**HVAC Replacement for
Summit Drive Elementary School
Greenville County School District**

Solicitation No: **124-33-9-29**

Addendum No. 2

DATE: October 12, 2023

SHEET
A-301

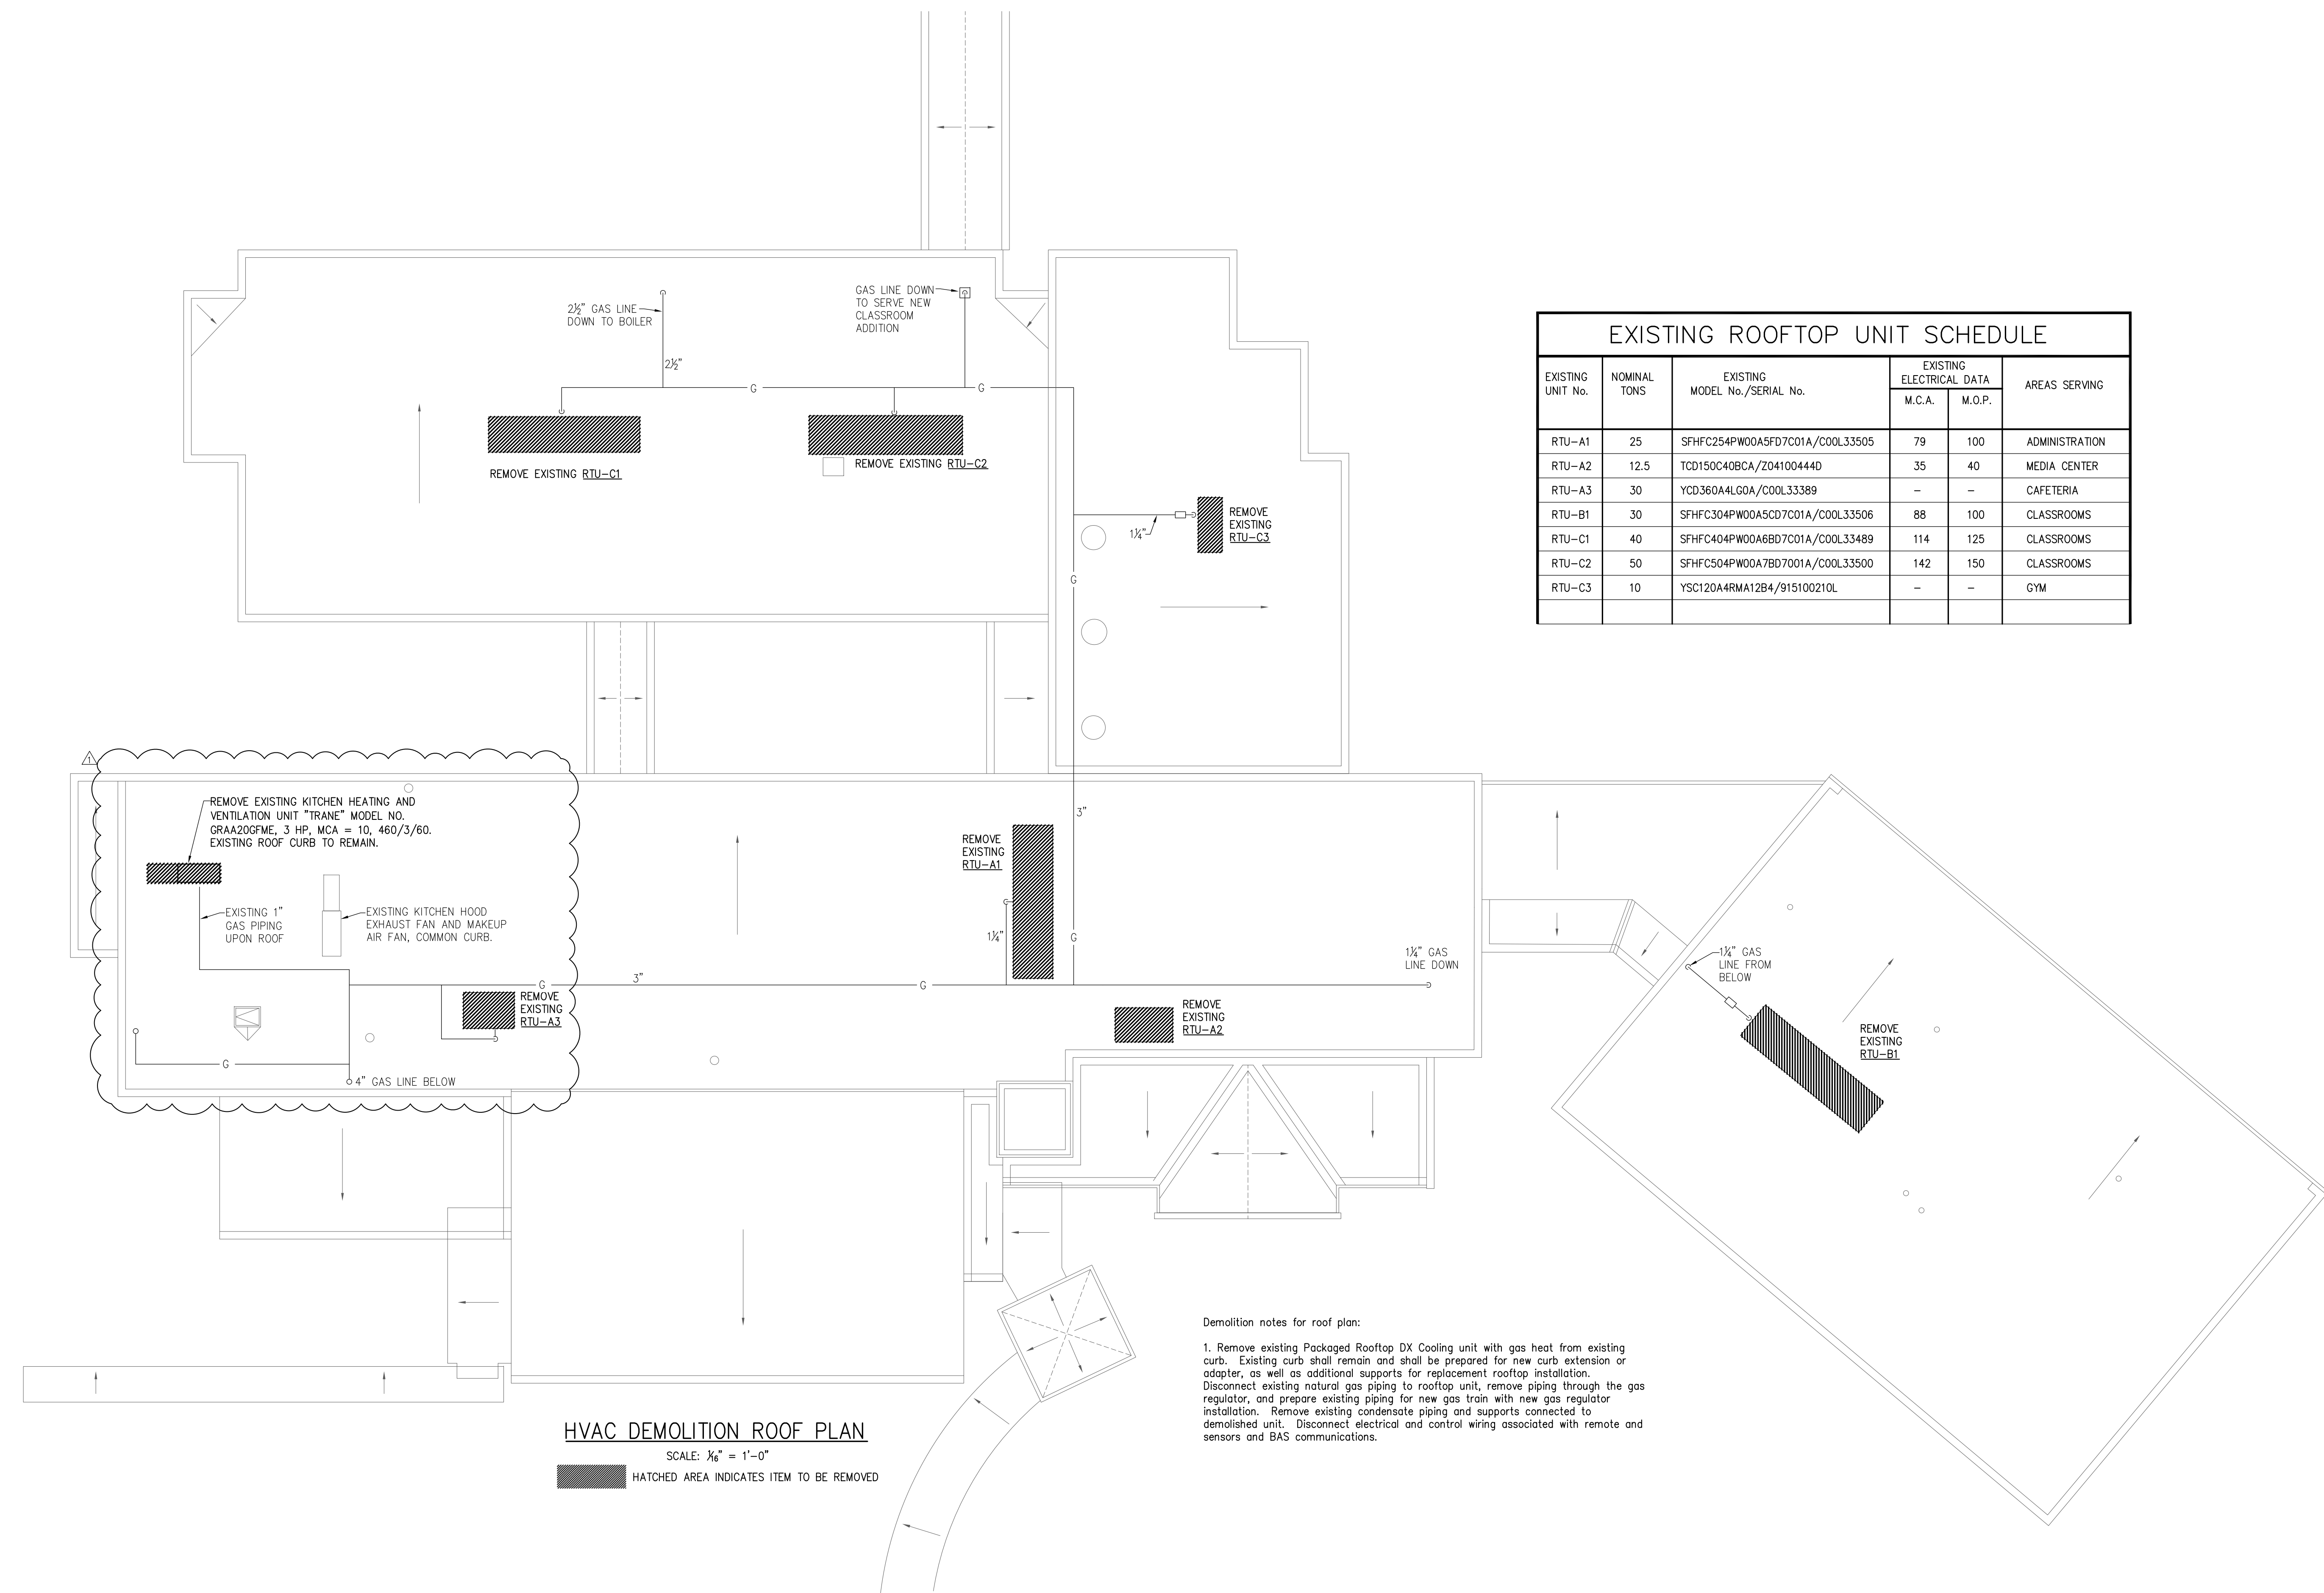
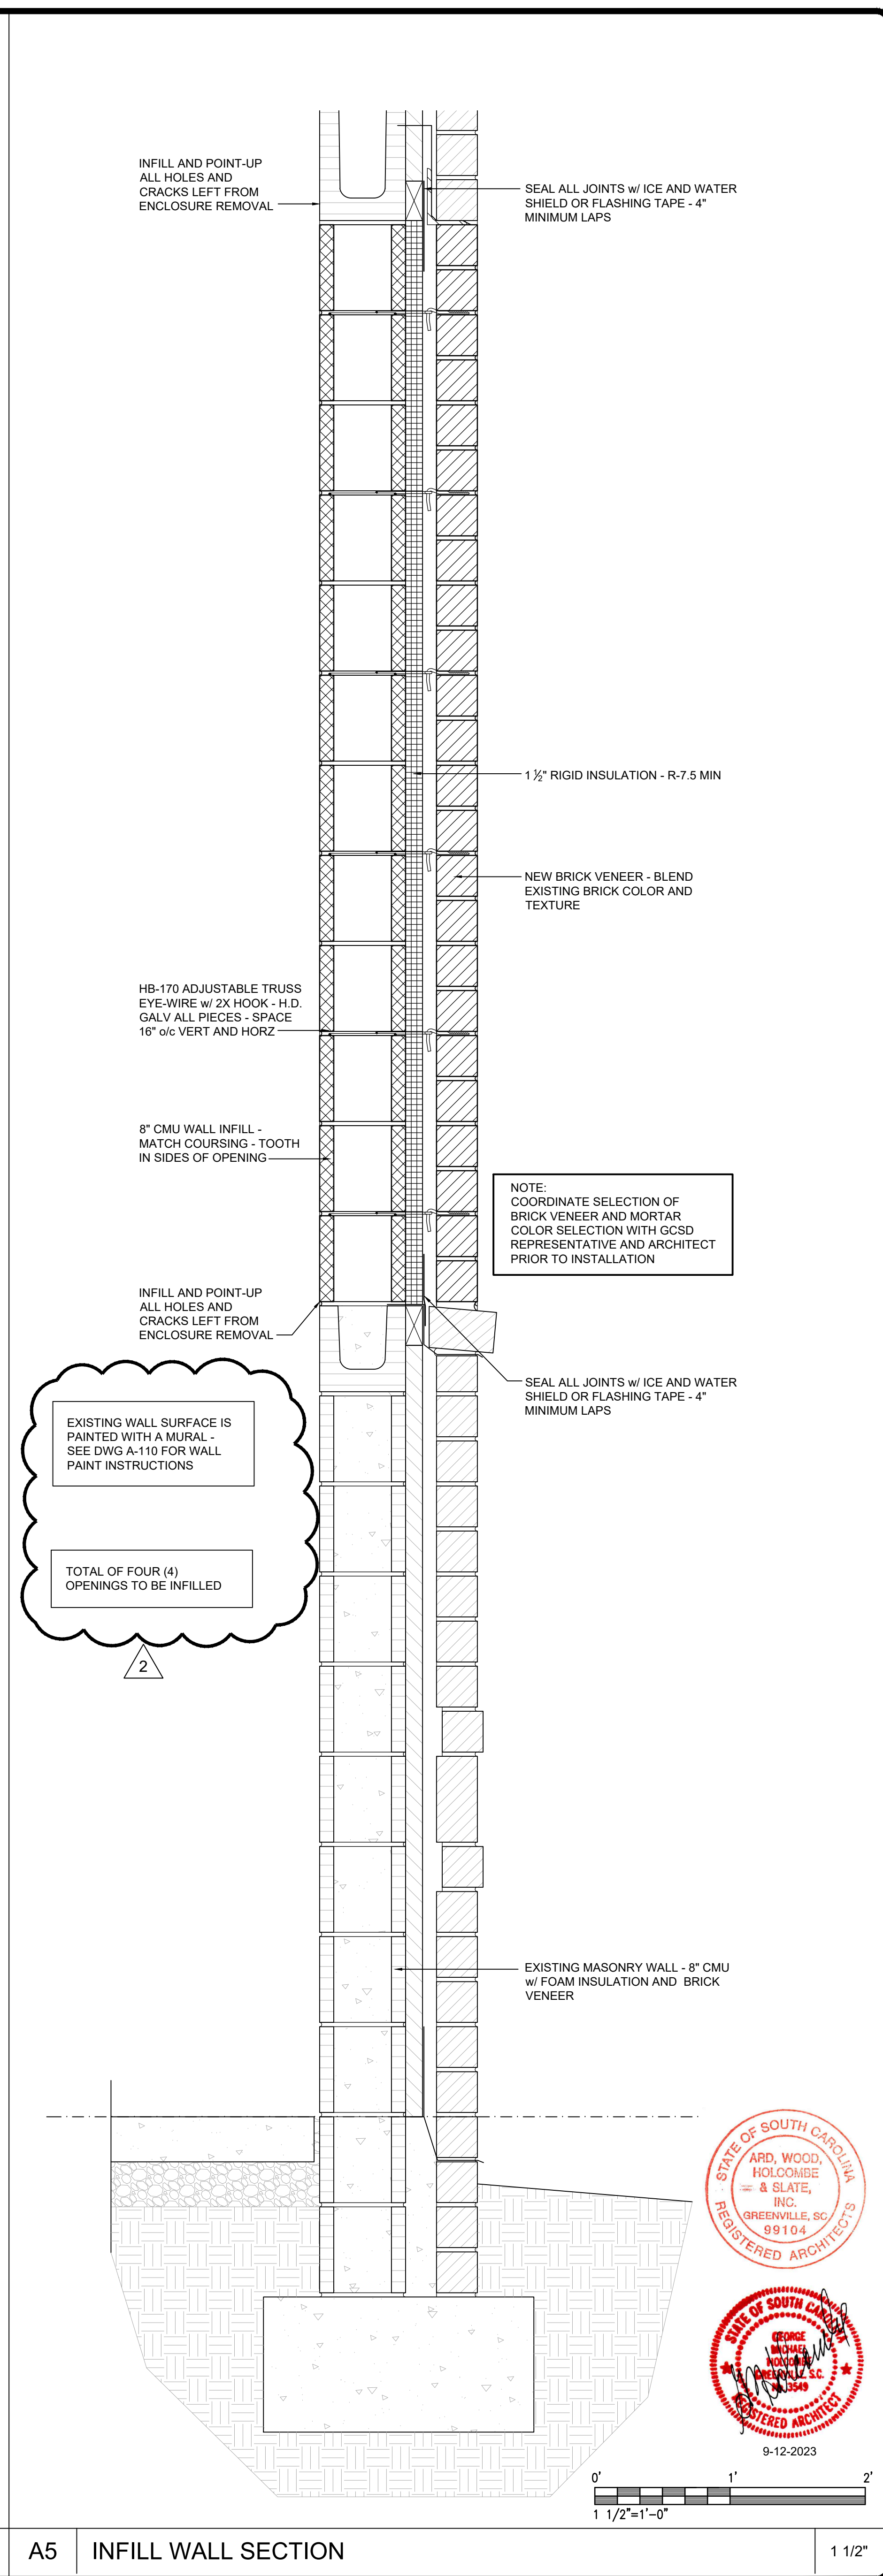
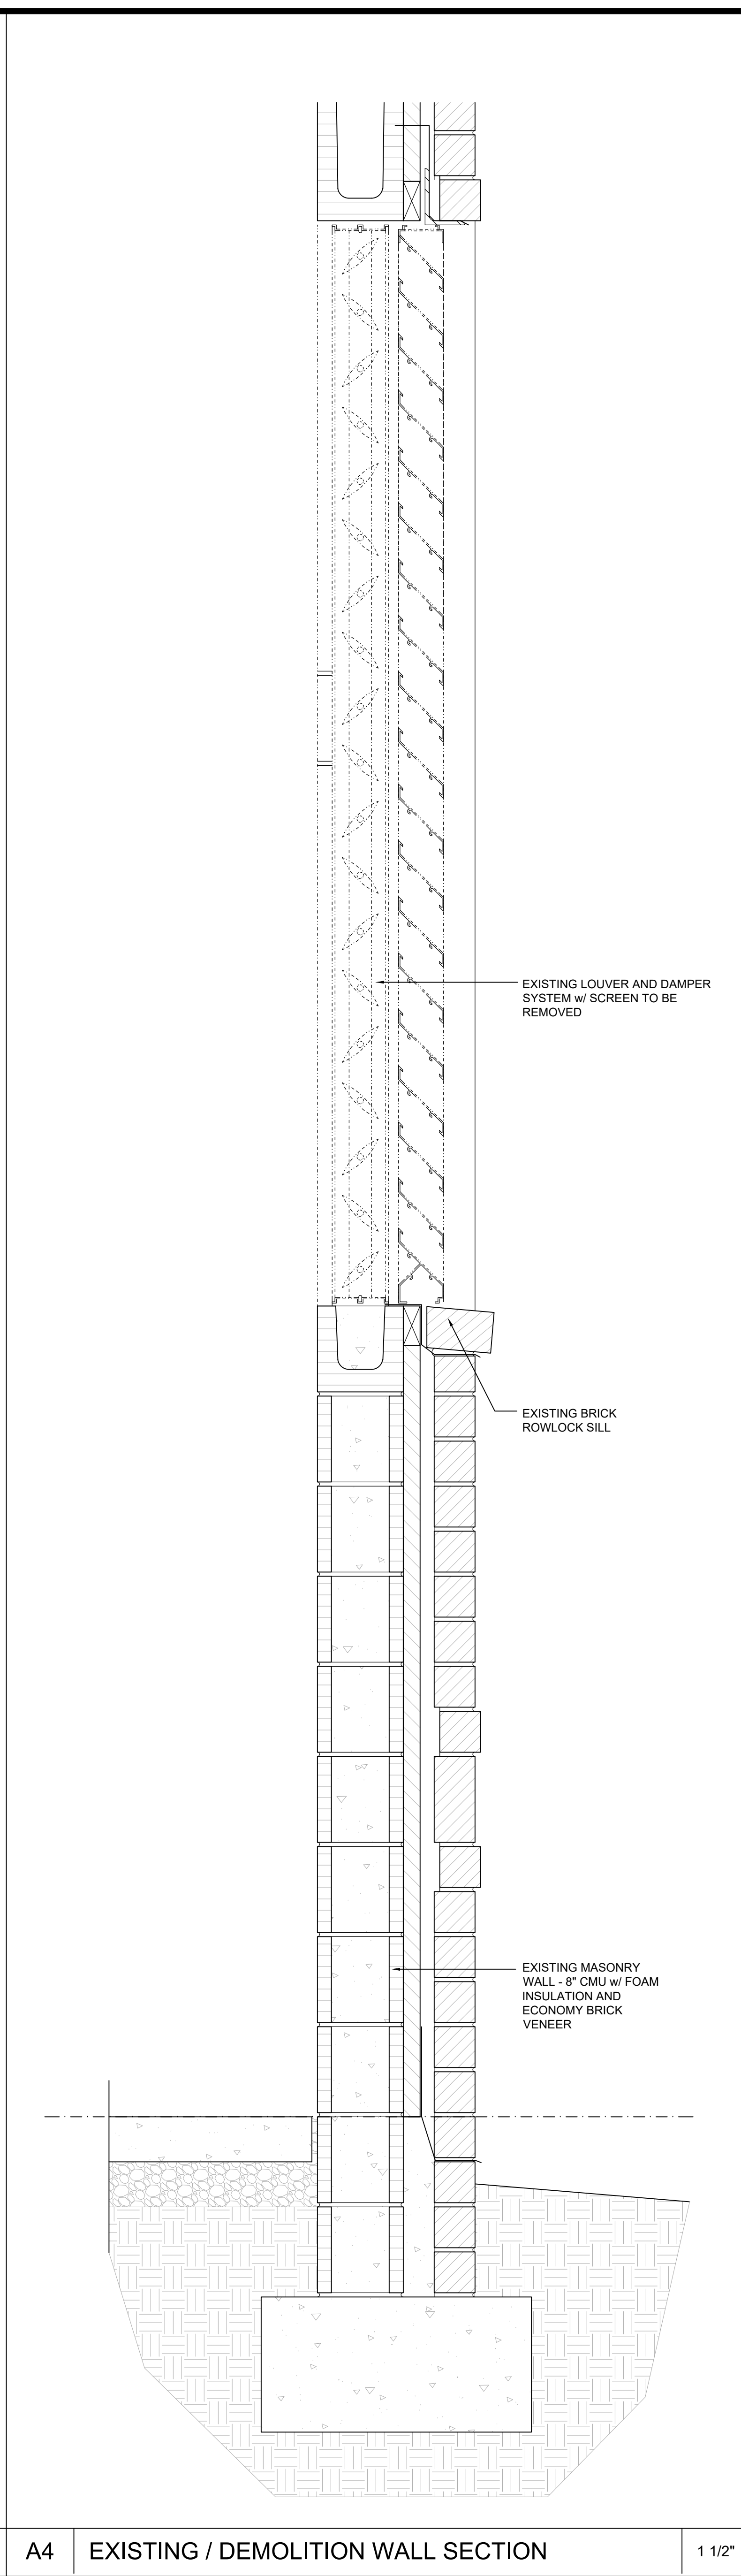
1. A-110, Overall Lower Level Floor Plan, Added note regarding scope of wall painting as well as added multiple references to A-301 wall sections.
2. A-301, Sections, Added clarification notes regarding wall painting and wall infill.

3. MD-5, HVAC Demolition Roof Plan, Revised extents of existing gas piping upon roof, added notes regarding demolition of existing kitchen heating & ventilation unit.
